Independent Review of

Hydrologic Modelling for SDL Adjustments

FINAL REPORT

30 September 2017

Figure 1: Iterative Process to Determine the Supply Contribution (Source: Figure 1 of the SDLA Model Report)

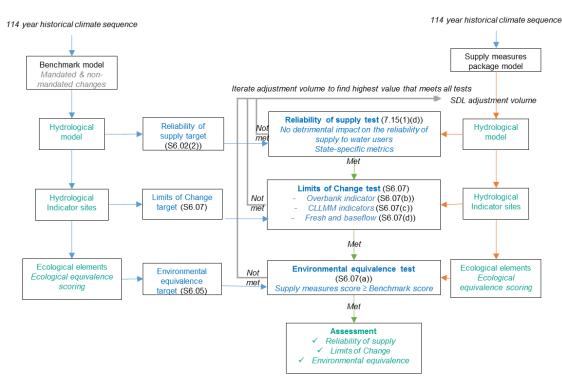
Because of the requirements described in **Sections 3.2** to **3.5**, the process of determining an SDLA volume requires numerous iterations within the modelling framework. **Figure 1** illustrates this iterative process and demonstrates how an initial estimate of the SDLA supply contribution requires adjustment in order to satisfy the limits of change whilst also complying with both the environmental score and the reliability constraints.

Based on the interviews that have been conducted with the MDBA staff and review of the *SDLA Model Report* the reviewer has not identified any inconsistencies of approach with the Basin Plan when calculating the SDLA supply contribution.
